**BEFORE THE
ARIZONA CORPORATION COMMISSION**

Docket No. E-00000V-19-0034

Sierra Club Comments on Arizona Public Service's 2020 Integrated Resource Plan

Figure 1: APS Portfolio Cost and CO₂ Emission Reduction Chart (APS Figure ES-4)

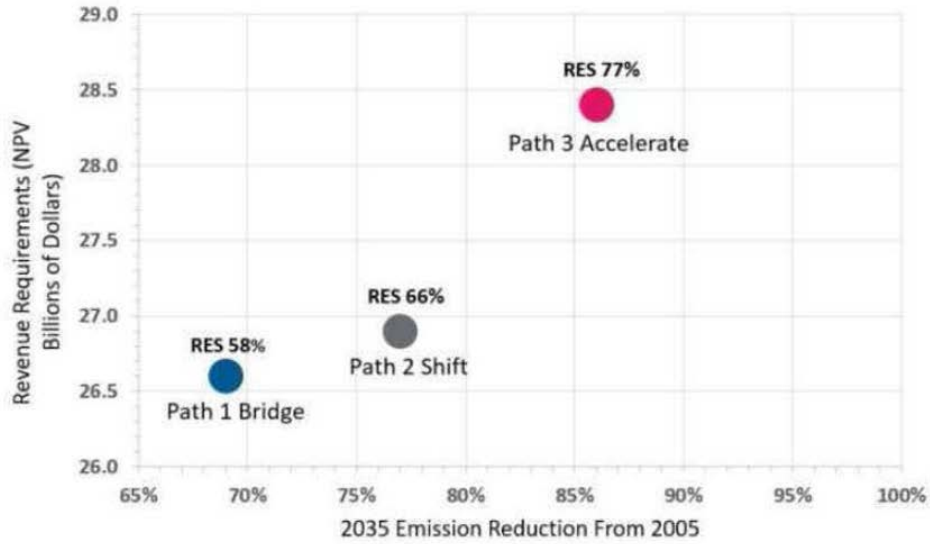
APS claims that it has not selected a preferred scenario from among the Bridge, Shift, and Accelerate scenarios; but its misleading presentation of the NPVRR results is concerning and skews in favor of the natural-gas heavy Bridge scenario.¹⁵ Specifically, as shown in Figure 1, APS presents the total cost and emissions of each scenario in a manner that makes the Bridge scenario appear significantly cheaper (less than half the cost) of the Accelerate scenario, when in reality the 2020 – 2035 NPVRRs between all scenarios differ by less than seven percent. Figure 2 below shows a corrected version of APS's NPVRR graph. APS should correct its misleading chart in its IRP and be clear about the actual magnitude of differences among the portfolios.

Figure 2: APS NPVRR and emission Reduction with Sensitivities

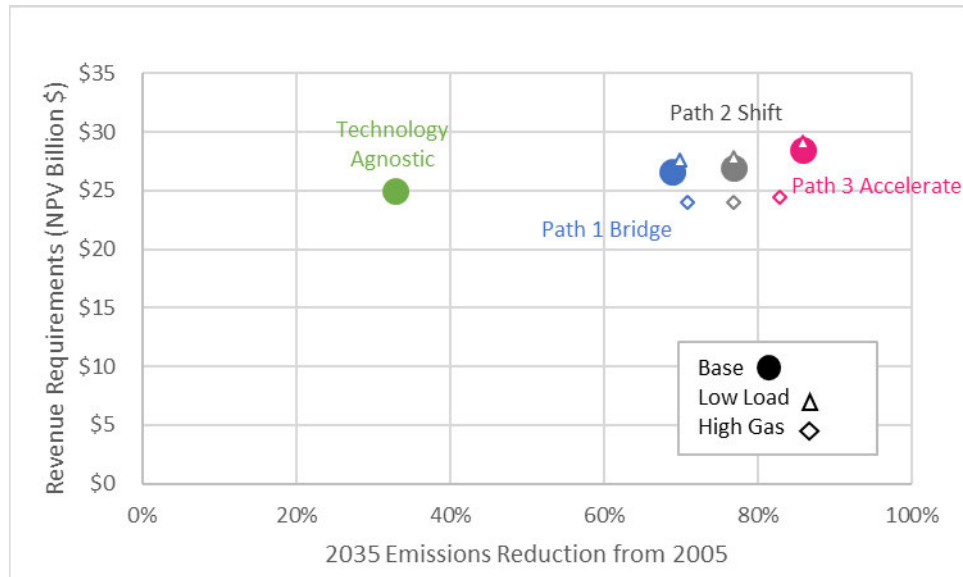
Additionally, when APS tested sensitivities around load and natural gas forecasts, it found that the difference between scenarios decreased in both cases (as shown in Figure 2). This critical finding shows how sensitive APS’s results are to its input assumptions, in particular its two assumptions around load forecast and natural gas prices that we find APS has over-projected (as we will discuss later).

Figure 3: APS Historical and Forecasted Peak Load Growth

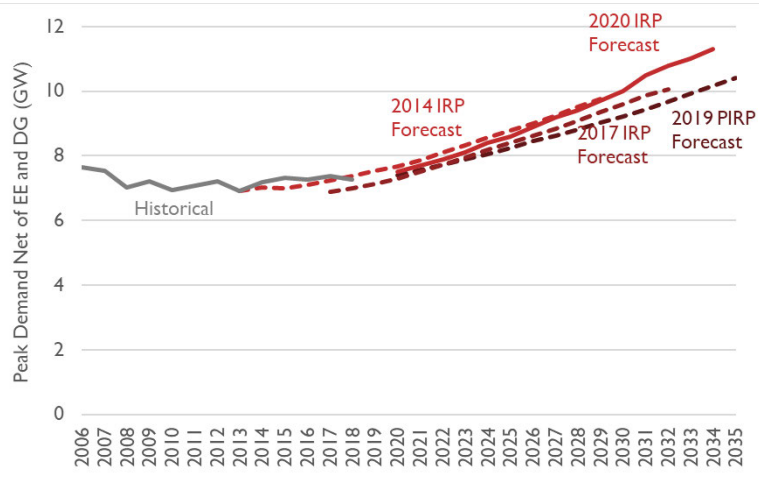
APS's base load forecast assumes that annual peak demand and energy needs increase at a compound annual growth rate (CAGR) of 2.1 percent and 2.7 percent over the IRP planning period of 2020–2035.³¹ That is attributed in large part to APS's assumption around population growth, economic growth, data center growth, and changing customer trends related to electric vehicles (EVs) and distributed generation.³² Historically, load growth has been relatively flat in the region at 0.32 percent from 2008–2018.

APS should be required to update its IRP based on a load forecast that reflects a more reasonable growth projection that aligns with historical observed trends.

Figure 4: Load Sensitivities

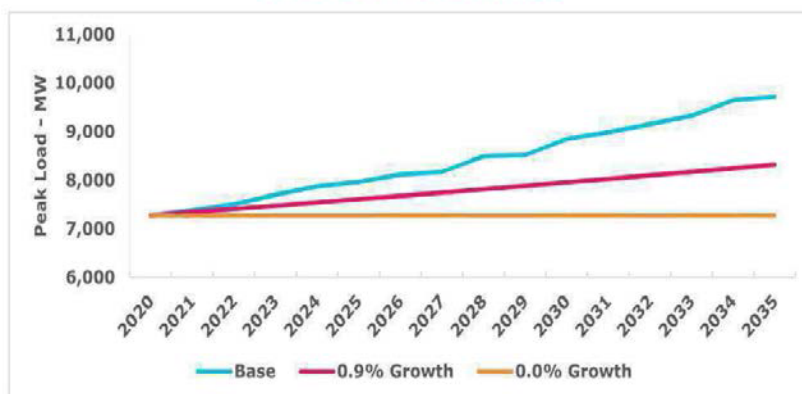
APS also models two lower load growth sensitivities as shown in Figure 4³⁷ (at the requirement of the Commission under ACC Decision No. 76632); however, it relies on the highest forecast as its base forecast.³⁸

With lower load sensitivities assuming (a) just under 1 percent annual average load growth and (b) no load growth, the NPVRR delta between the three scenarios decrease significantly. Specifically, with a load growth forecast that matches historical trends (no load growth assumed), the NPVRR difference between the fossil-heavy Bridge portfolio and the renewable-heavy Accelerate portfolio dropped to less than a third the level we see under the high load baseline scenario.³⁹ In other words, APS’s reliance on unrealistic and high load growth assumption makes its fossil-heavy portfolio appear more economic than a renewable-focused portfolio.

The Commission should require APS to base its final IRP scenarios on a lower and more realistic load forecast that is aligned with historical trends. The Company should not be allowed to procure natural gas resources based on the results of its current IRP modeling.

Figure 5: APS Natural Gas Price Forecast

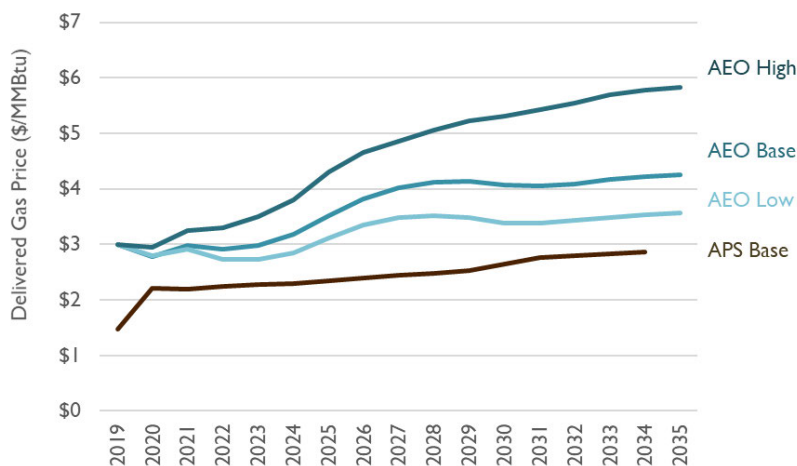
In addition to the capital cost, natural gas prices also have a significant impact on the resource economics seen by the model. APS's natural gas price forecasts⁶¹ are once again significantly lower than the industry-standard forecasts published by EIA AEO⁶² as shown in Figure 5. This repeats a pattern we have seen in the last two IRPs of APS projecting lower natural gas prices than other leading sources. Fuel costs comprise a significant portion of the NPVRR for fossil resources. Therefore, APS's reliance on artificially low gas price forecasts makes its fossil-heavy portfolio look cheaper relative to a renewable portfolio that relies more heavily on zero-fuel cost resources.

APS does test several natural gas price forecast sensitivities with lower and higher price assumptions. As we would expect, APS's analysis shows that with increased gas prices the NPVRR delta between the Bridge and Accelerate portfolios decreased.⁶³ But the Company relies on its very low base gas price forecast for all its final portfolio results.⁶⁴

Given the interplay among renewable capital costs, natural gas capital costs, and natural gas fuel prices, the Commission should require that APS conduct sensitivities that reflect costs closer

to the industry standard. Specifically, lower renewable resource capital costs, higher natural gas capital resource cost, and higher natural gas fuel prices.
